09YOL0017
 03-YOL/SUT-Various
 Pacific Gas and Electric (PG&E) Line 406/407 Project
 Draft Environmental Impact Report

1 **RESPONSE TO COMMENT SET J**

Subject: PG&E Line 406 and Line 407 Natural Gas Pipeline Project (CSLC EIR 740) (SCH# 2007062091) – Draft EIR Comments

1 RESPONSE TO COMMENT SET K

Conceptual Land Use Plan

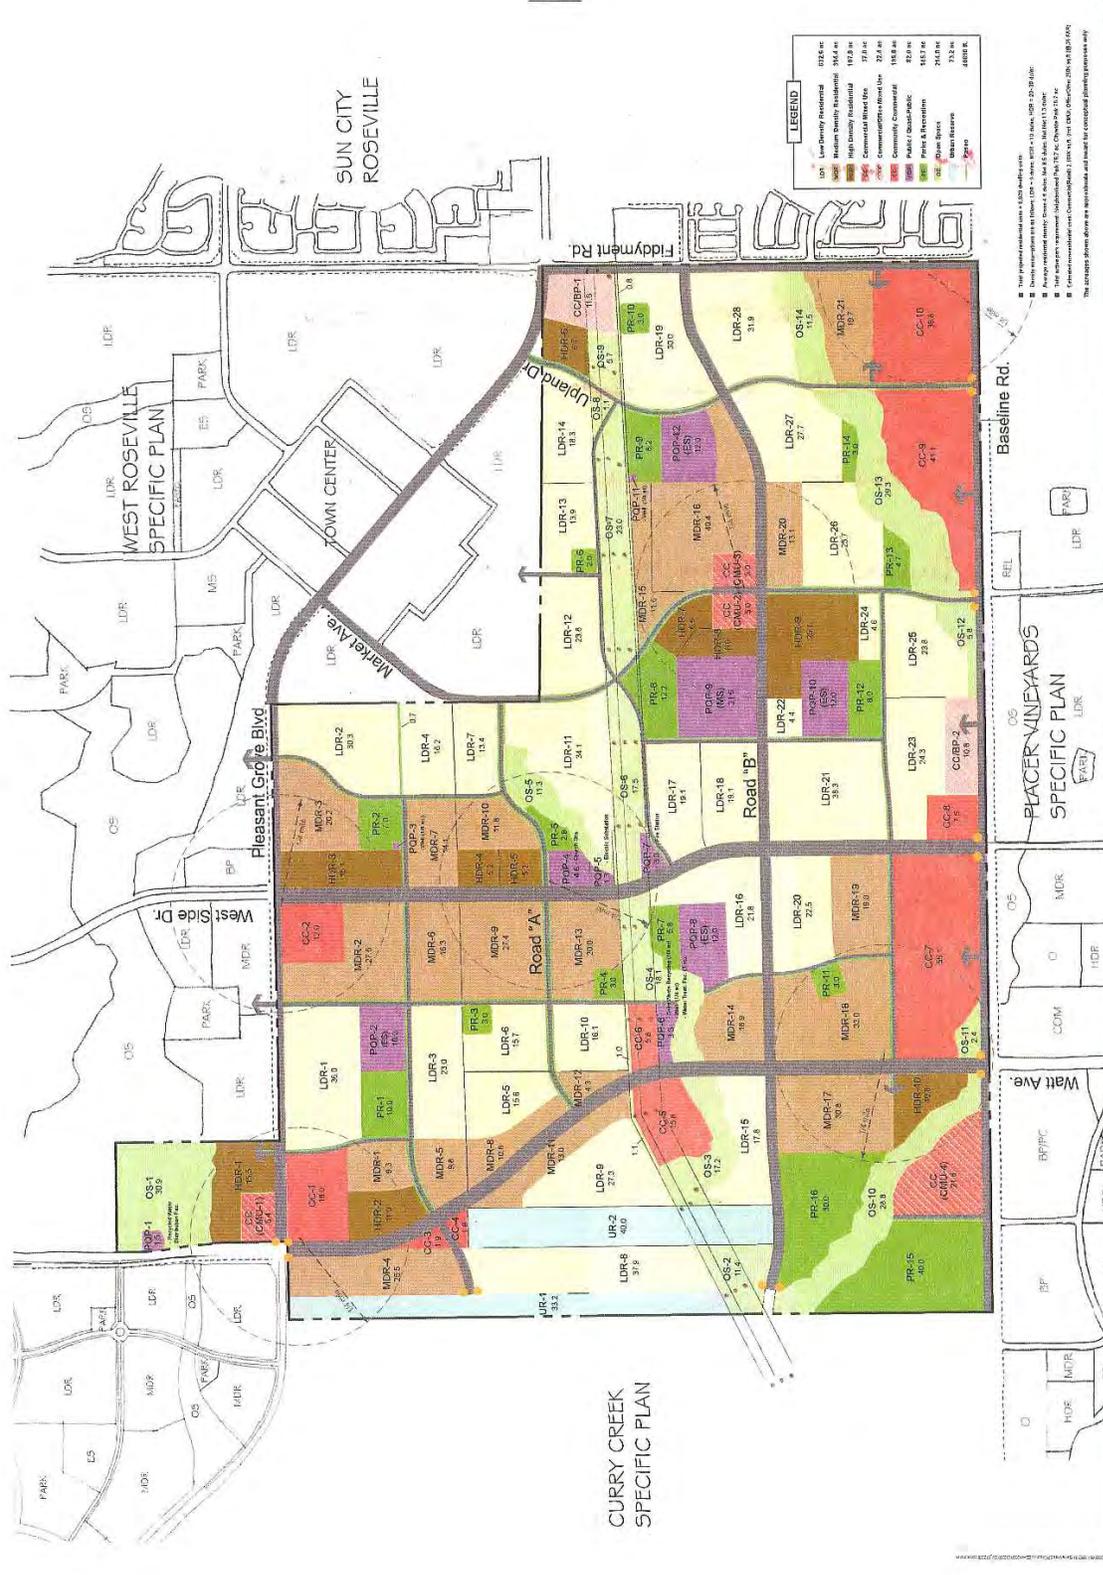
The City's design concerns center on the need to coordinate the pipeline's horizontal and vertical alignment and related above ground facilities with future road alignments, final grades, landscaping, utility and infrastructure needs of the SVSP. These concerns were discussed at the June 5th meeting where the City and PG&E agreed to share design information and work together with the goal of developing compatible facilities. The City requests that the following design issues be considered as part of this ongoing effort:

- The proposed location of the Baseline Road Pressure Regulating Station (PRS) conflicts with SVSP parcel CC-10. Parcel CC-10 is planned to be a regional shopping center. The City requests that the Baseline Road PRS be relocated westerly to future SVSP parcel OS-13 or other acceptable location (see attached land use plan). At the June 5th meeting it was agreed that SVSP land owner consultants would provide additional information related to this proposed relocation and that PG&E would further evaluate the proposal in relation to proposed HDD work and resource issues. In a subsequent email to the City PG&E indicated that there is some limited potential for adjusting the location of the station but there are issues that need to be addressed before the final location can be confirmed and that PGE is willing to work with the City of Roseville and the Sierra Vista developers to locate a mutually acceptable location once the design parameters firm up. The City looks forward to working closely with PG&E on this issue.

1 **Response to Comment K-2, Bullet 3** As noted above in response to Bullet 2,
2 PG&E has utilized the best available information regarding the Baseline Road
3 alignment. PG&E will adjust the pipeline alignment if feasible once the road design
4 is finalized.

5 PG&E has located the 50-foot easement at the future Baseline Road back of curb
6 per plans provided by the design firm of MacKay and Soms. This easement is
7 planned to be contiguous with the proposed landscape strip.

14 **K-3** PG&E has indicated they advised City of Roseville representatives that
15 the station location has some flexibility; however, the existence of sensitive
16 resources, and operational constraints, will limit potential locations. PG&E
17 representatives are available to work with both the City and the CSLC on this issue.
